Wisconsin DNR Information Request Response

PREPARED FOR: Jim Pardee and Ben Callan/ Wisconsin Department of Natural Resources
COPY TO: Waukesha Water Utility
PREPARED BY: CH2M/Jacobs & Greeley & Hansen
DATE: September 21, 2018

The Wisconsin Department of Natural Resources (WDNR) is reviewing the previously submitted Great Water Alliance (Program) updated Environmental Impact Report (EIR) to address the Wisconsin Environmental Policy Act (WEPA) requirements for the Waukesha Great Lakes Water Supply Program. The following questions were submitted to the Program for additional information on September 13, 2018. This document provides immediate answers to some of the questions and identifies which questions will be answered after further investigation.

Figure 2-1 Route Alternatives M1, M2, and M3

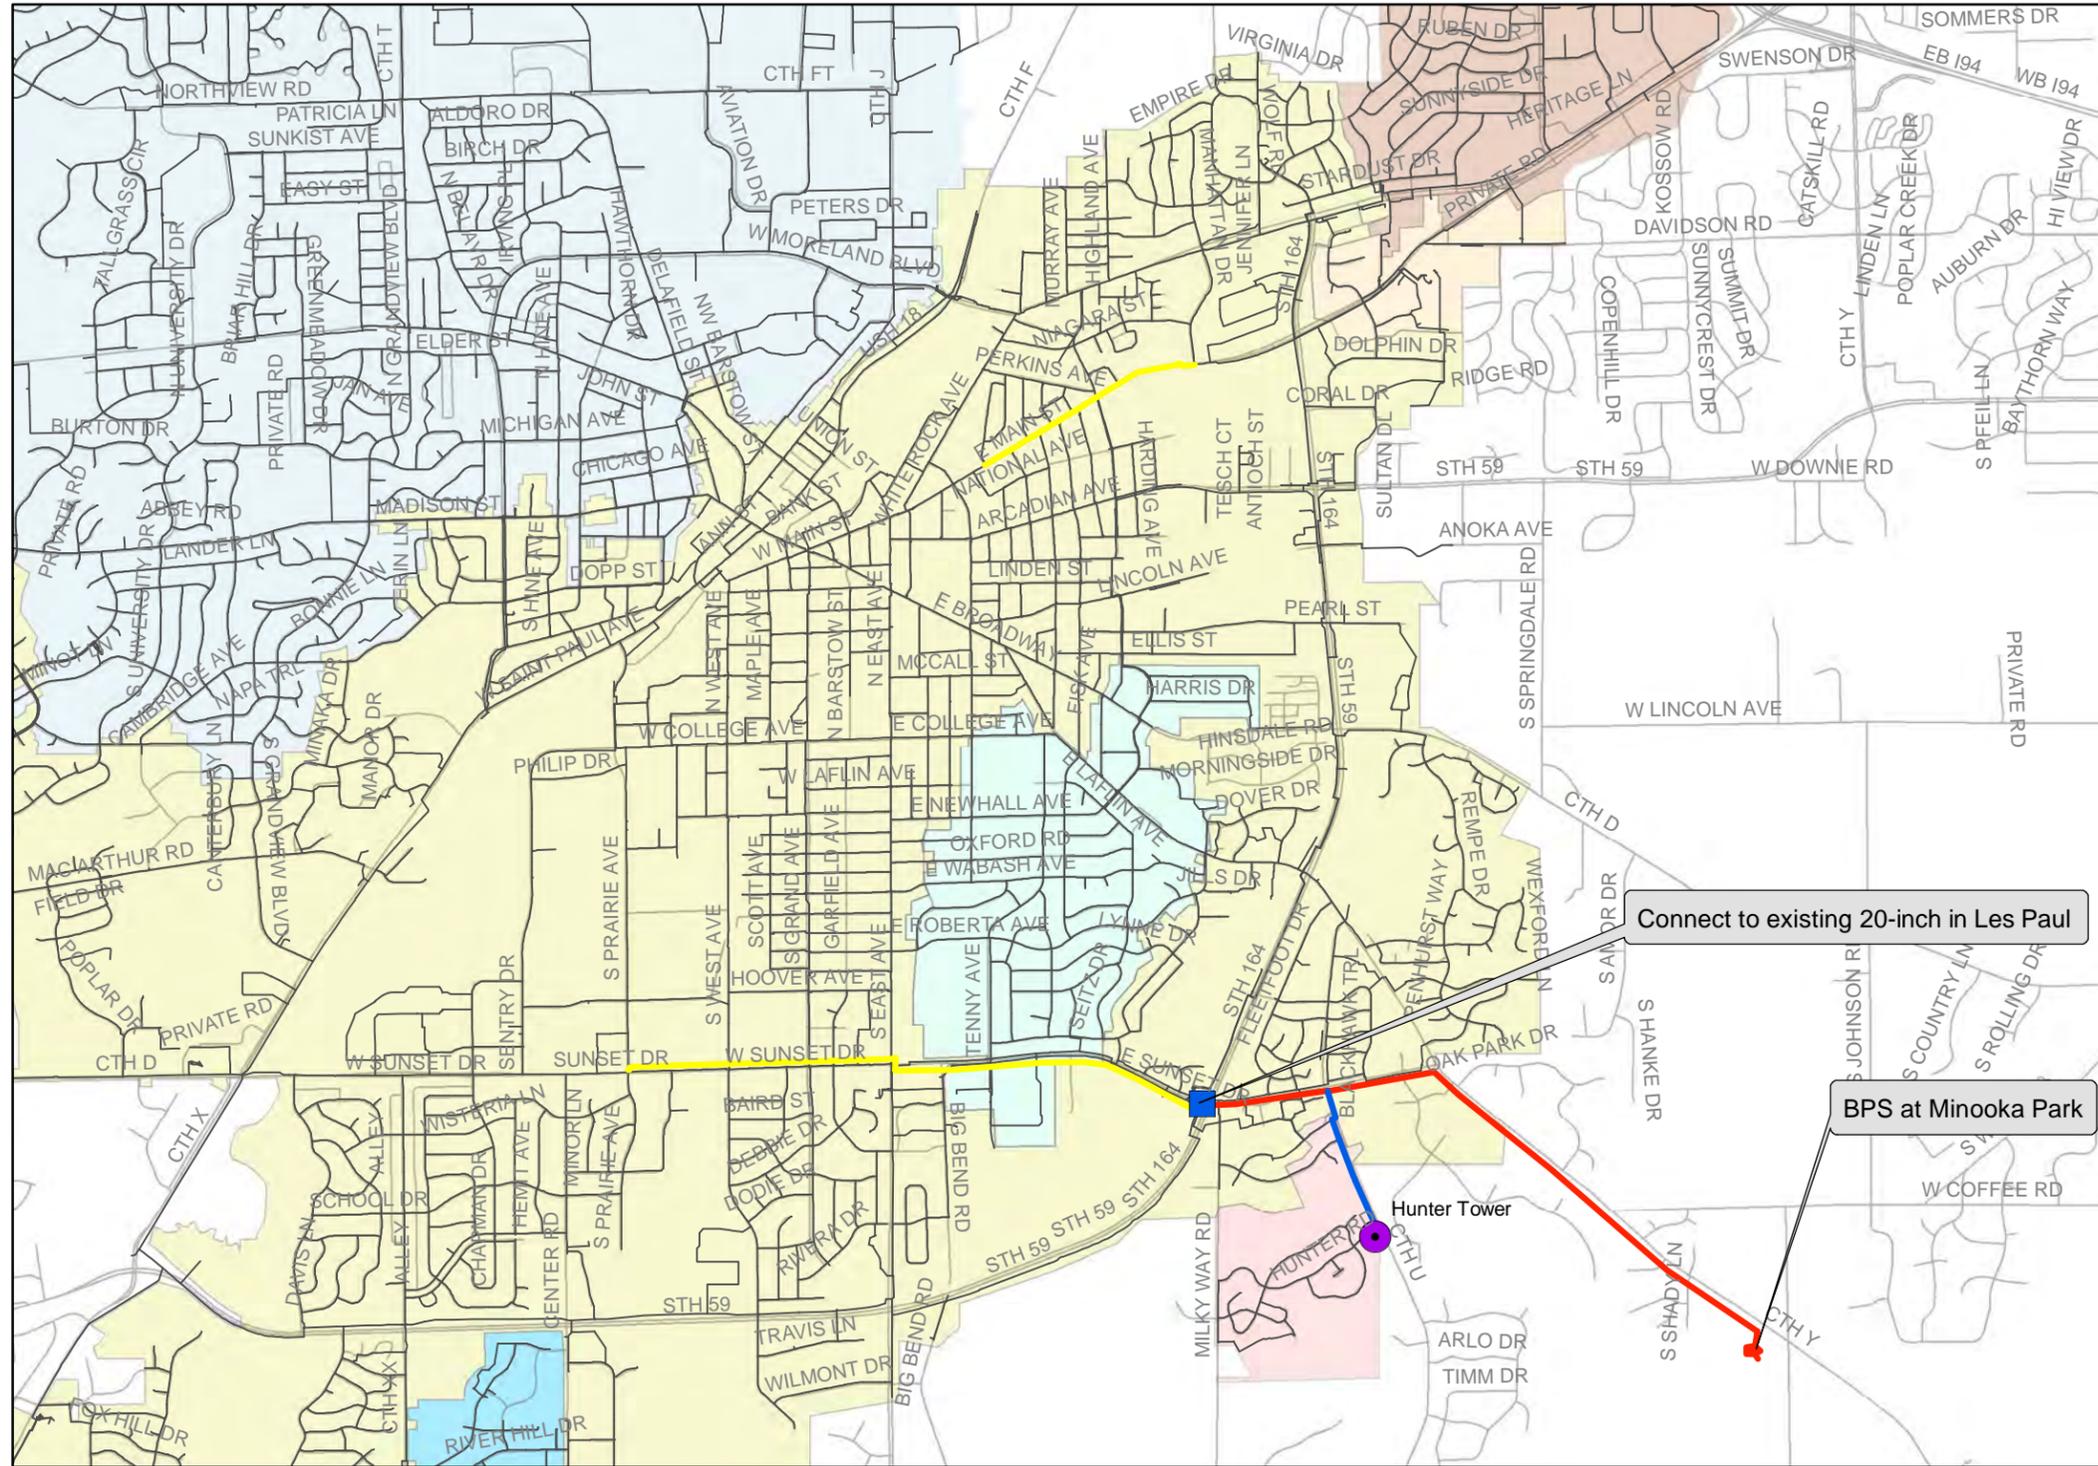
1. Has the proposed location for the water supply pump station (WSPS) been determined? What about for the alternative pipeline routes?

The three Milwaukee Supply Route alternatives have been determined and Route M-1 is the preferred route. An overview map of all three Milwaukee Supply Routes is attached; see document '1_B_Milwaukee Route Alternatives'. This overview map is from the Milwaukee Supply Route study, which was completed prior to the WSPS location change to 76th Street and Oklahoma Avenue. At that time, the assumed location of the WSPS was 60th Street and Howard Avenue, so all three routes start there.

15 - Proposed Draft Construction Schedule

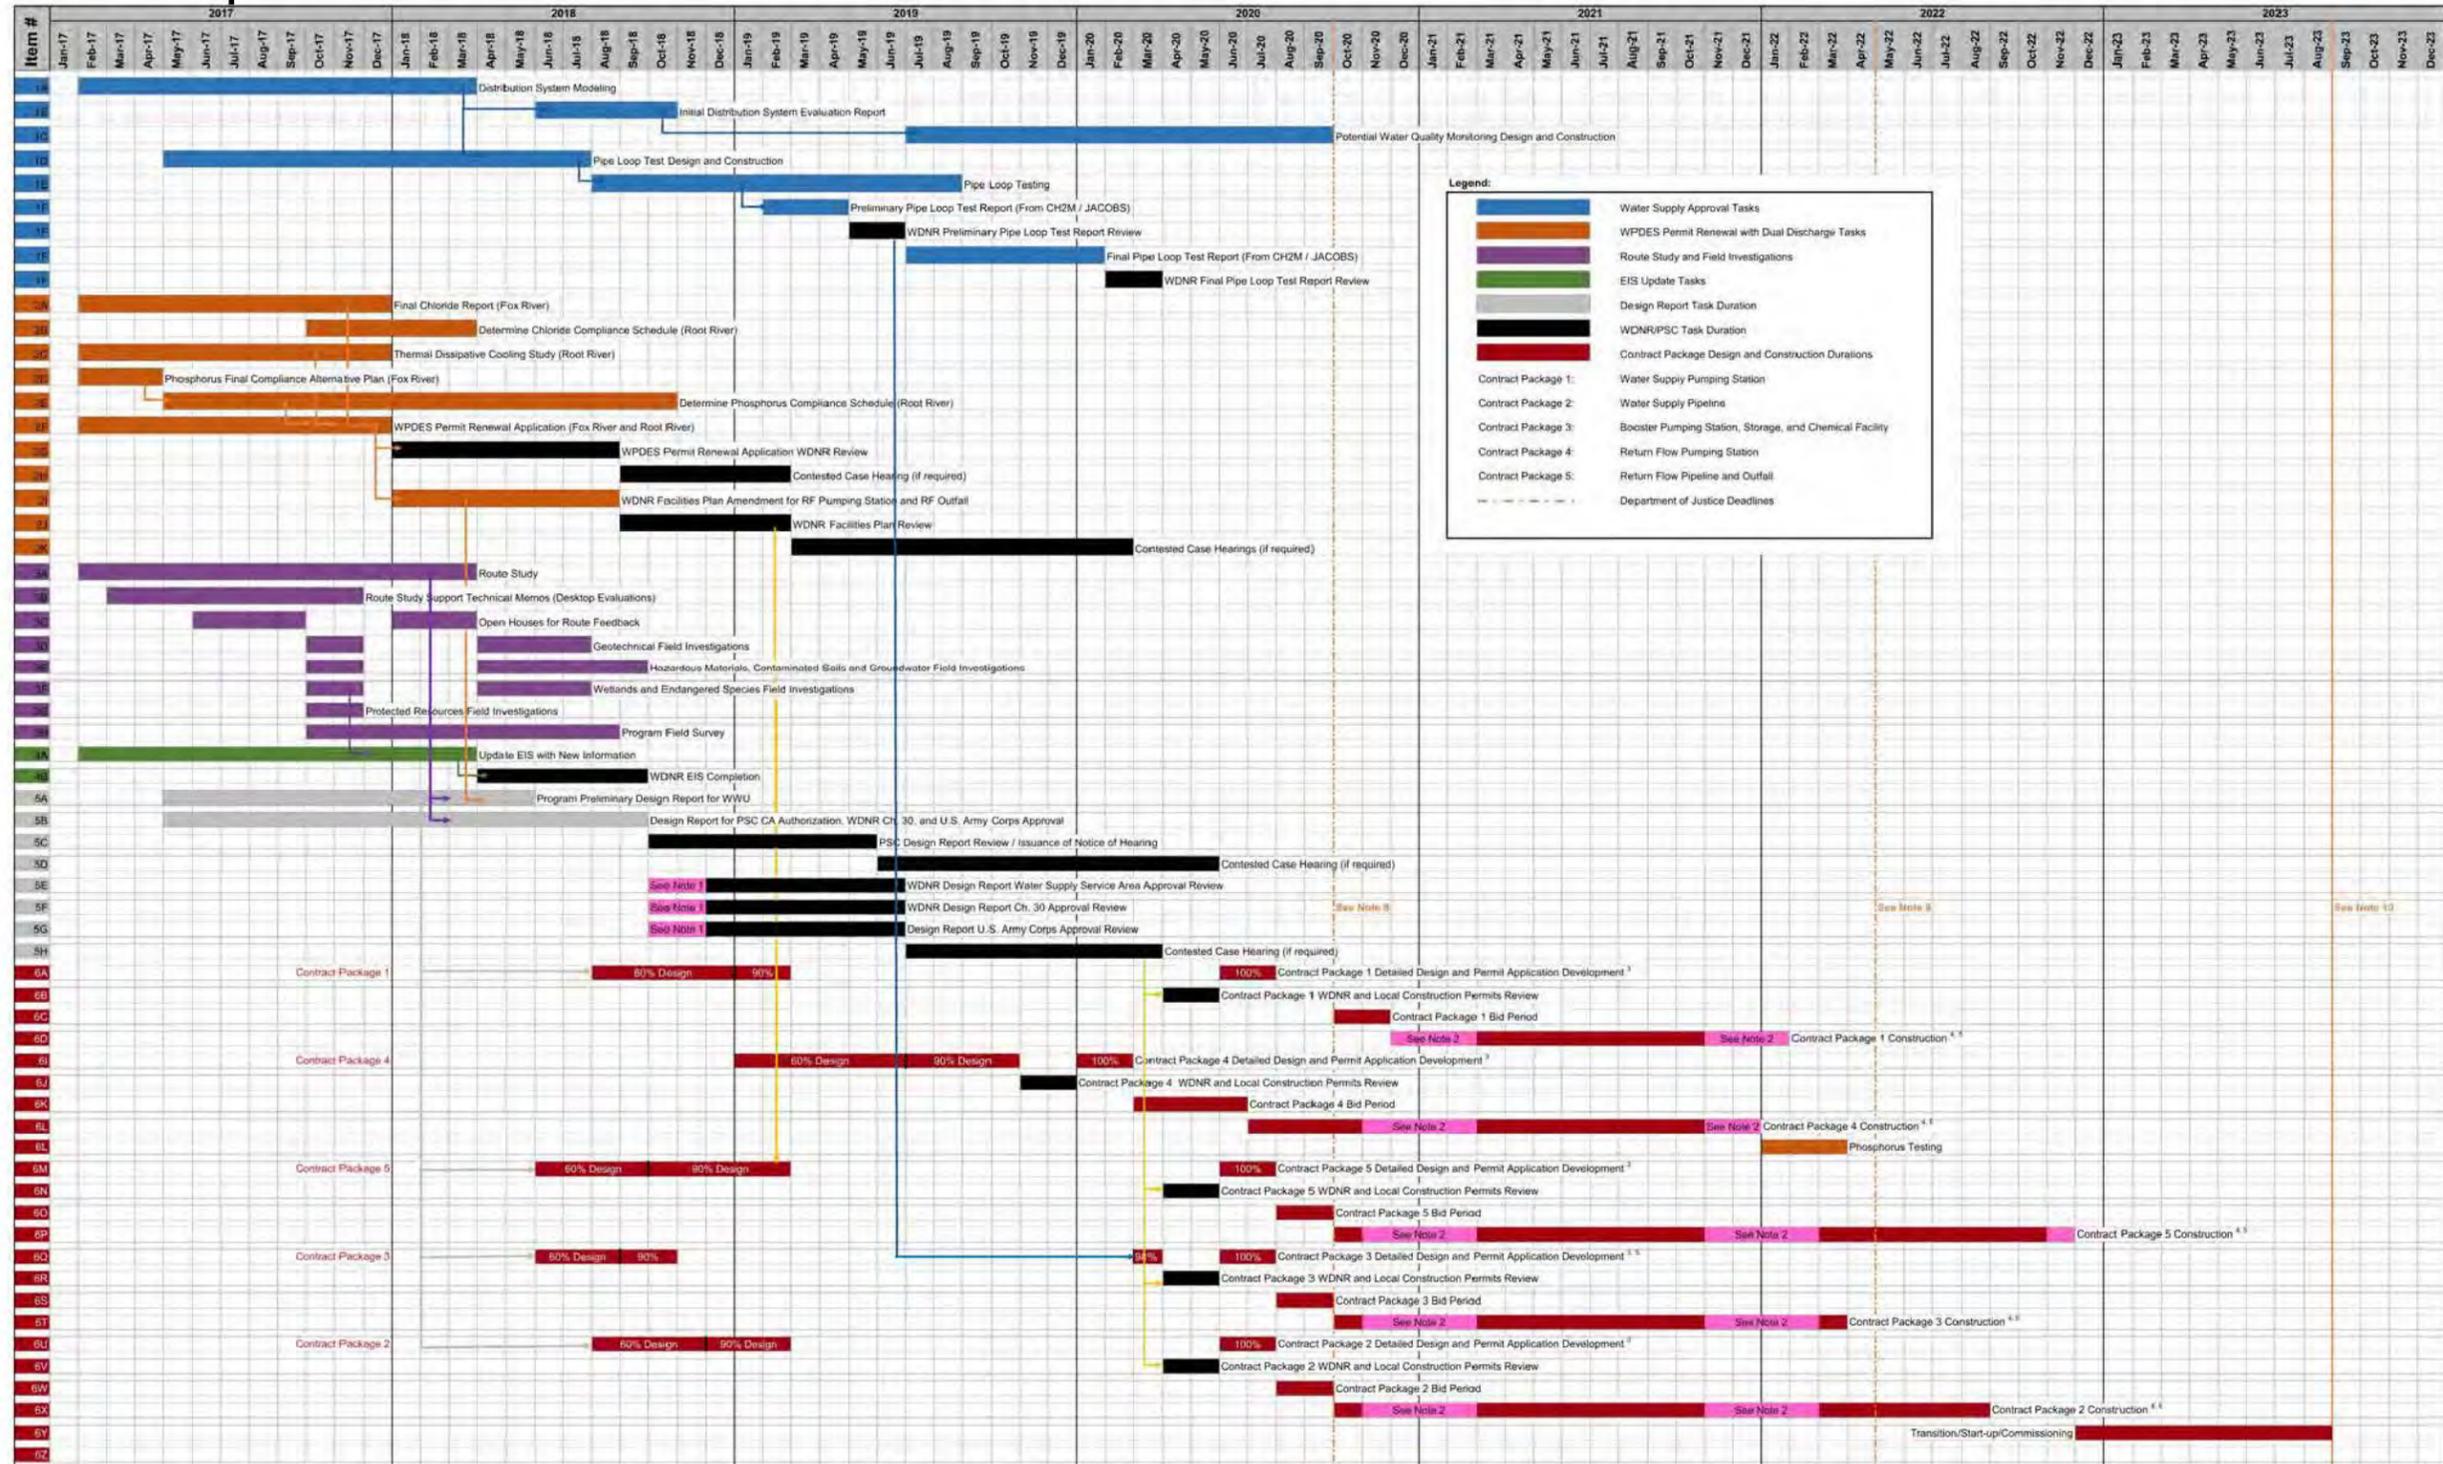
15. Need planned construction schedule.

The draft proposed construction schedule is attached. See '15_Proposed Draft Construction Schedule' document.
